# CITY OF LYNDEN

TECHNICAL REVIEW COMMITTEE  
Conditional Use Permit Application

## CITY OF LYNDEN TECHNICAL REVIEW COMMITTEE STAFF REPORT

CUP #21-01 Duffner Mobile Home Park FINDINGS, CONCLUSIONS, AND RECOMMENDATION

Technical Review Committee – Required and Recommended Conditions Exhibit 10-4-2021

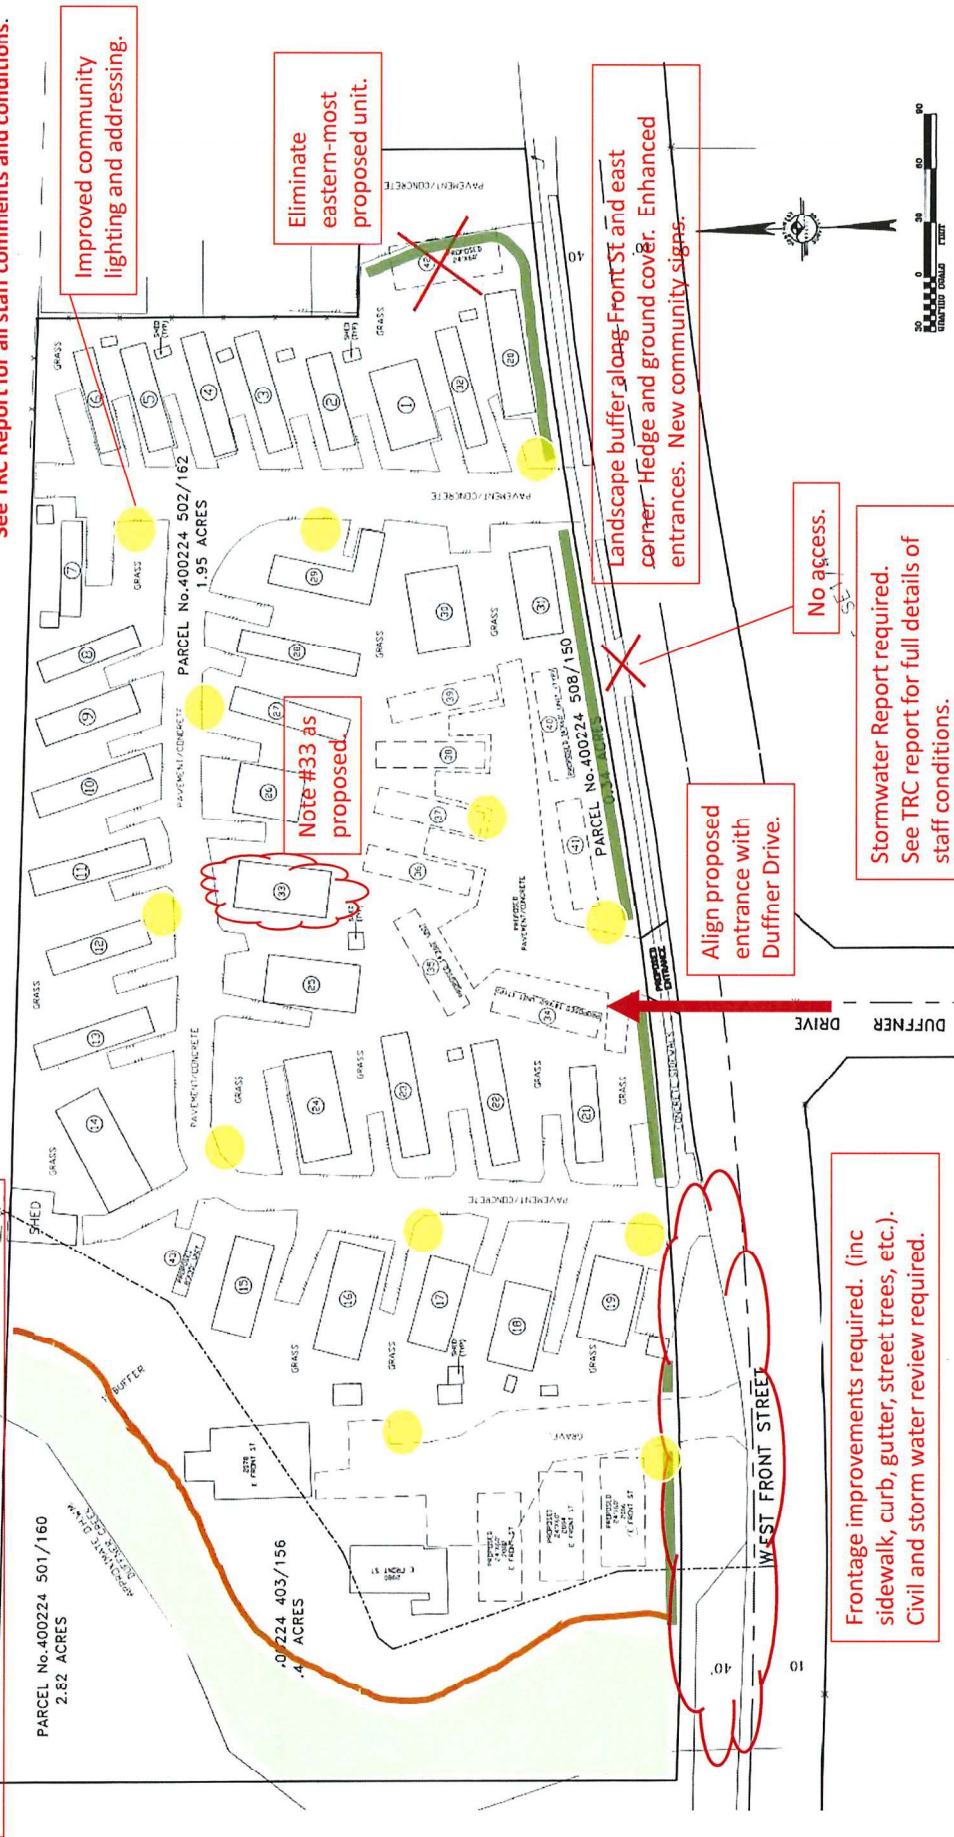
Split rail fence and critical area signs at top of bank. Clean up of refuse. Erosion control planting on creek bank.
